**Adams River (Harbour) Visual Assessment
Southwest Cutblocks
FL A94922: SB95C, SB95E; A95215: SB96U
September 22, 2017
RDI Resource Design Inc**

Findings and Conclusions

Viewpoint NT2- VP with clearing - no on-site viewpoint determination

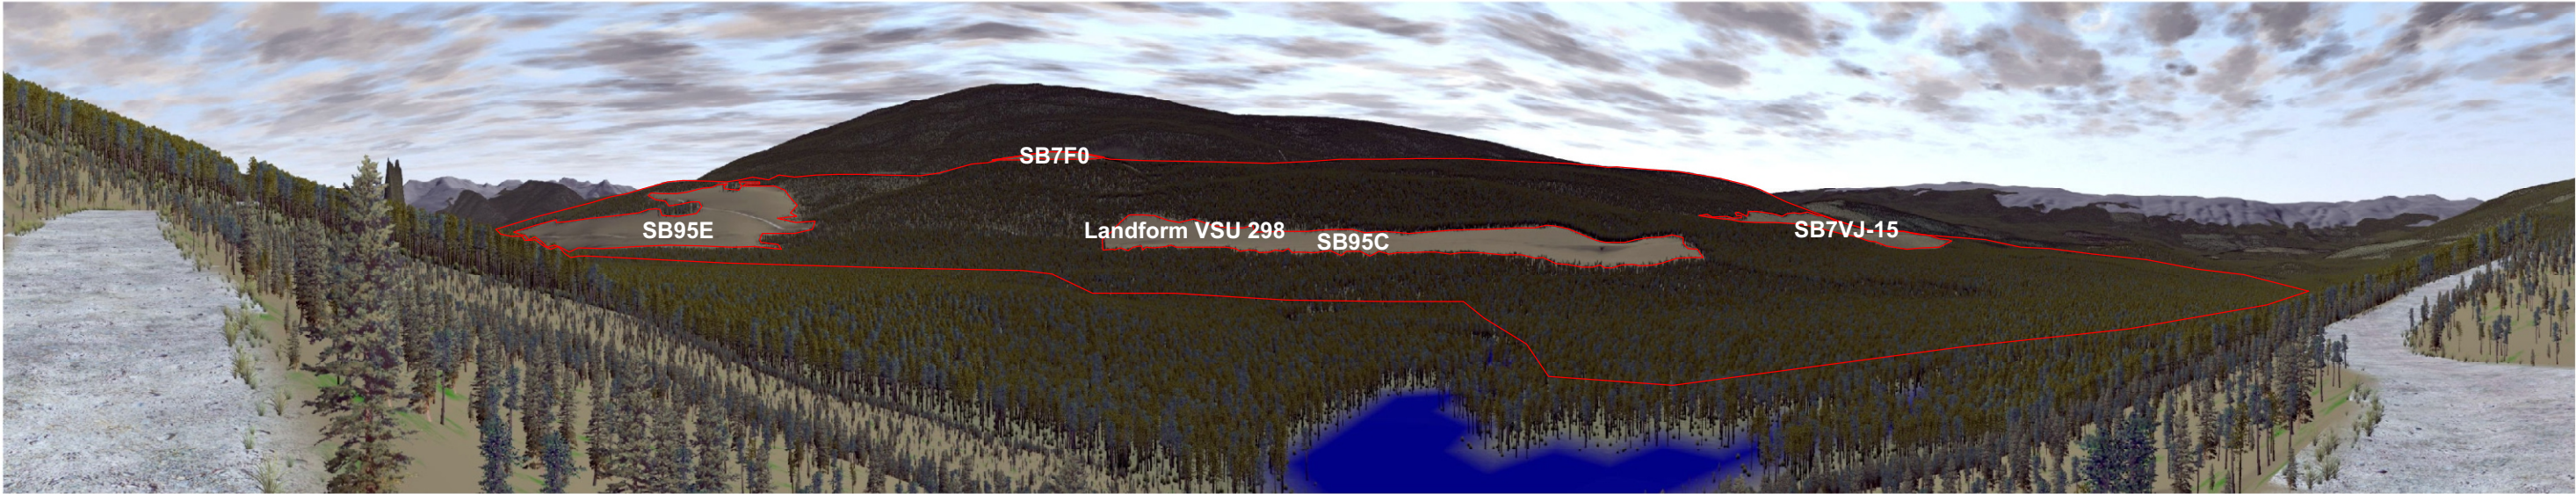
The landform (VSU 298) has a Modification eVQO (M) east of the river. The Percent Alteration is 13.59%. The allowable VQO Percent Alteration range is 7.1% to 18%. The definition of the Modification Category of Altered Forest is very easy to see, and is:

A. large in scale and natural in appearance, or B. small to medium in scale but with some angular but with some angular characteristics.
SB95C is strongly lineal and angular in the cleared view, and would benefit from some leave patches. As the viewpoint simulation was produced with clearing in the model in front of the viewpoint, on-site determination of viewability is requested, with photographs and GPS. Until on-site verification is made, no adjustments are suggested at this time.
SB96U is seen as a minor sliver on the back landform (VSU 293) which also has a Modification eVQO.
SB95E, SB96U and existing SB7F0 cutblocks successfully follow the major lines of force, particularly the ridgeline delineating the landform VSU.

Viewpoint NT2-Riverbend- no VP clearing - no on-site viewpoint determination

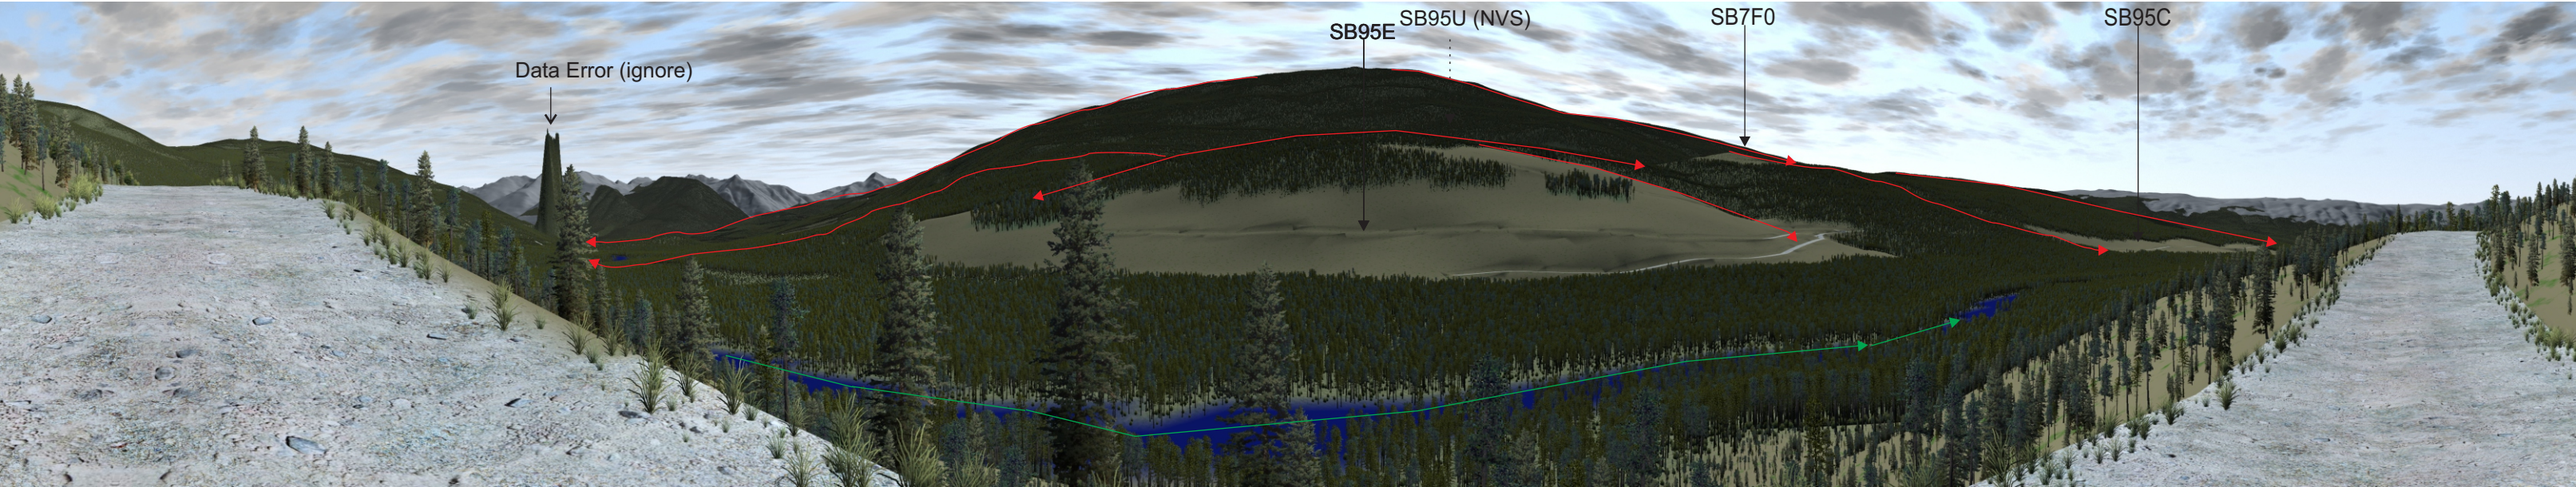
The landform (VSU 298) has a Modification eVQO (M) east of the river. The VQO may be very easy to see, and:
A. large in scale and natural in appearance, or B. small to medium in scale but with some angular but with some angular characteristics.
SB95C has minor linearity and angularity in this view. The other new blocks (SB95E, SB96U) are NVS and existing cutblock SB7F0 is a minor sliver.
Overall, the appearance easily meets the VQO. As the viewpoint simulation was produced with minor clearing in the model in front of the viewpoint, on-site determination of viewability is requested, with photographs and GPS.
Until on-site verification is made, no adjustments are suggested at this time.

Viewpoint NT3- with VP clearing- no on-site viewpoint determination

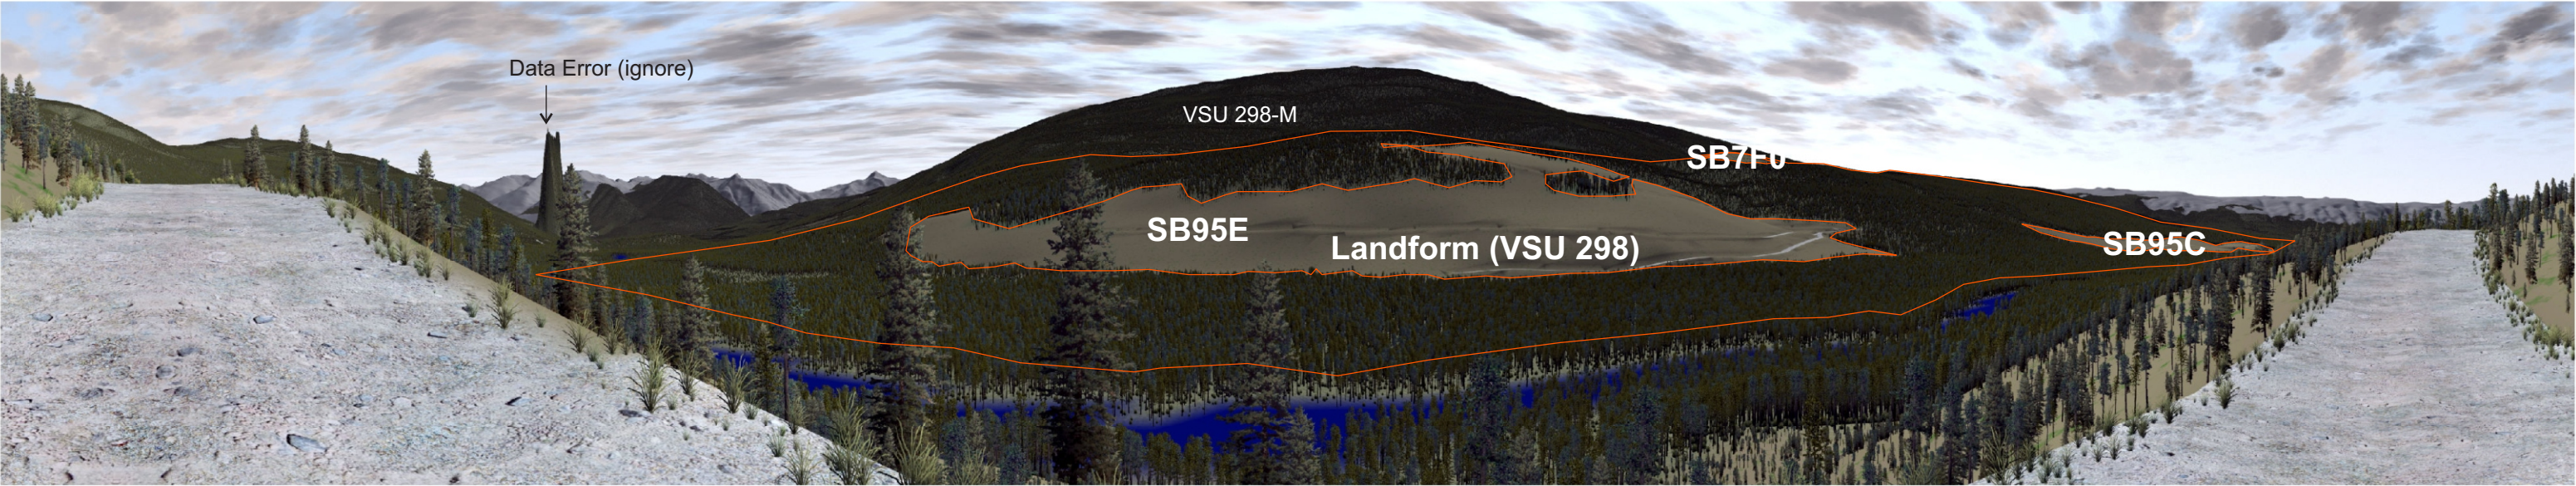
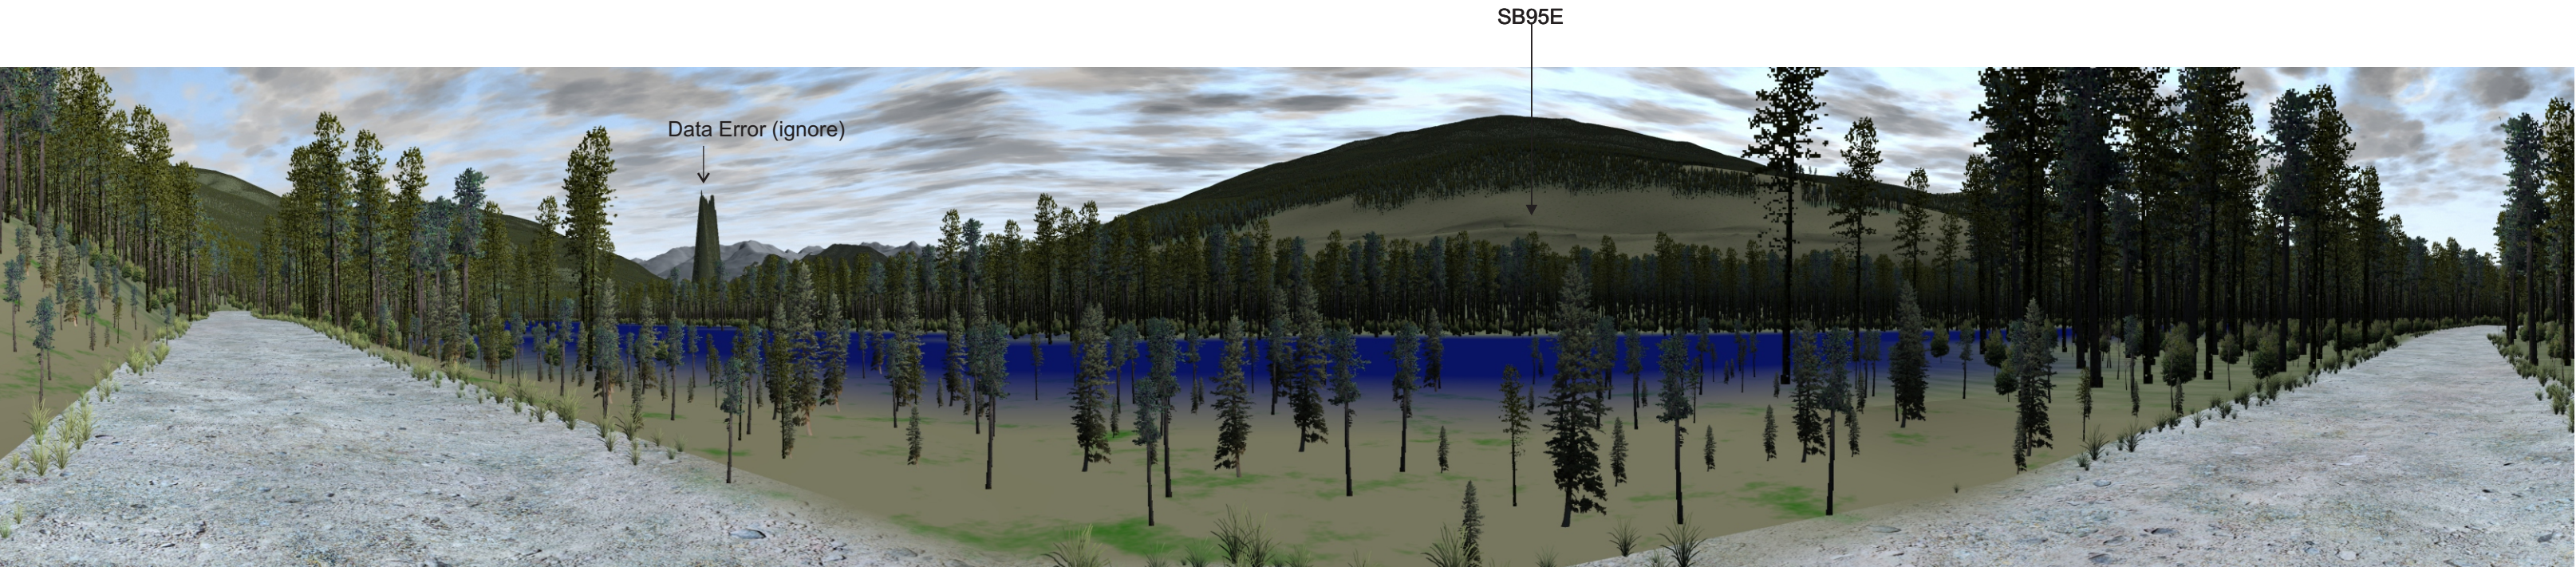
The landform (VSU 298) has a Modification eVQO (M) east of the river. The Percent Alteration is 29.48% in the cleared view from the road. The allowable VQO Percent Alteration range is 7.1% to 18%. The definition of the Modification Category of Altered Forest is very easy to see, and is: A. large in scale and natural in appearance, or B. small to medium in scale but with some angular but with some angular characteristics. SB95E is very large (28.47% alteration) and would require a significant reduction in scale to meet the VQO if visibility is as open as the trial cleared view predicts. SB95C is small (0,84% alt.) and successfully follows visual force lines and requires no adjustment from this viewpoint. On-site determination of viewability from the best observation point is requested from BCTS with GPS locations and photography. Until on-site verification is made, no adjustments are suggested at this time. SB96U is not seen in the upper landform (VSU 293) as it is behind the leading ridge. The existing SB7F0 cutblock successfully follows the major lines of force, namely the ridgeline delineating the landform VSU.
